5.2 T220501 PA - 74-76 Ahern Road, Pakenham VIC 3810 - Construction of Seventeen (17) Dwellings on a Lot

Responsible GM: Lili Rosic
Author: Benjamin Jones

APPLICATION NO.:	T220501
APPLICANT:	Mainline Property Investments Pty Ltd c/o Urban Arc Planning
LAND:	Lot 1 PS317592E 74 - 76 Ahern Road, Pakenham VIC 3810
PROPOSAL:	Construction of Seventeen (17) Dwellings on a Lot
PLANNING CONTROLS:	General Residential Zone - Schedule 1 Development Contributions Plan Overlay - Schedule 1
NOTIFICATION & OBJECTIONS:	Pursuant to Section 52 of the <i>Planning and Environment Act 1987</i> , the application was advertised by the placing of signs on site and sending notices in the mail to nearby property owners. Five (5) objections were received.

Figure 12 - Proposed upper floor plan identifies extensive double-storey built form throughout the site.

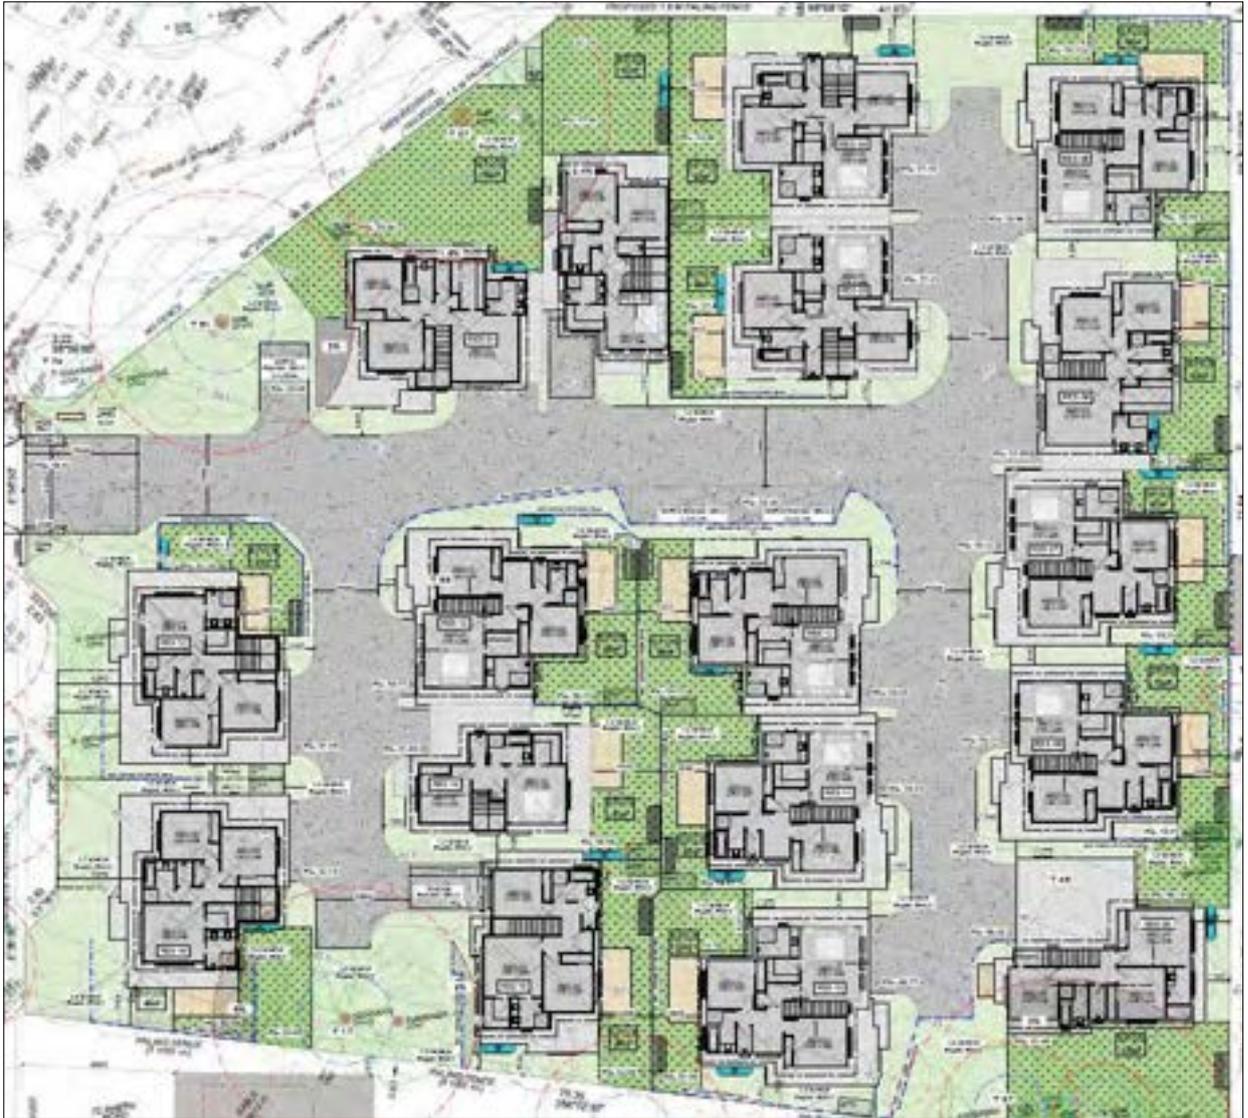
The 'Upper Floor Plan' best identifies the substantial and excessive double storey elements located throughout the site, with substantial and excessive internal accessways required to provide vehicular access to the dwellings. This is exacerbated by the site being located on a relative highpoint, and as such the built form will be seen from various directions.

The density of the development, as well as the continued double-storey elements are not an existing, or preferred character element when assessing the site and surrounds.

due to the built form outcomes of continued double storey through the depth and width of the site, density, bulk and massing.

Figure 22 – Proposed Development Elevations (South) displaying uniform design and limited variation in design.

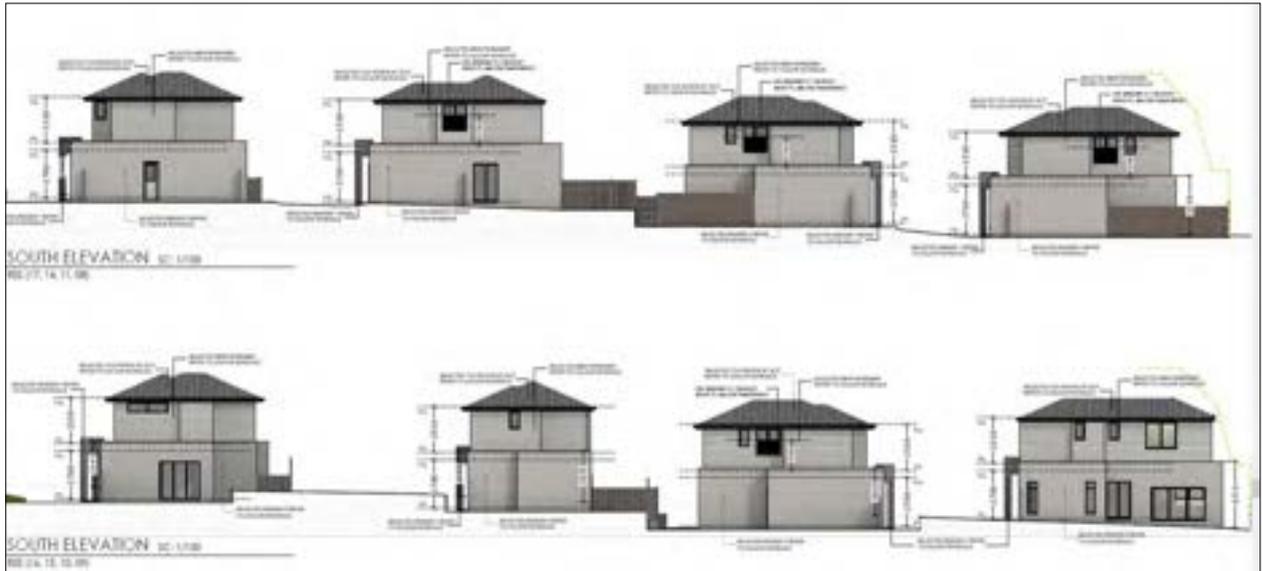
The slope of the land results in various areas of cut, fill, pads and retaining walls to allow for such intensive development whilst continued double storey-built form and a lack of varied materiality results in a ‘cookie cutter’ design which appears to have focused on achieving maximum yield as opposed to considering the site and surrounds on its merit. Elevation plans identify a relatively uninspiring and bleak built form outcome that does not respond to or respect the character of the area.

Figure 23 – Proposed Development Elevations (North) displaying uniform design and limited variation in design.

Figure 24 - Proposed Development Elevations (Internal) displaying uniform design and limited variation in design.
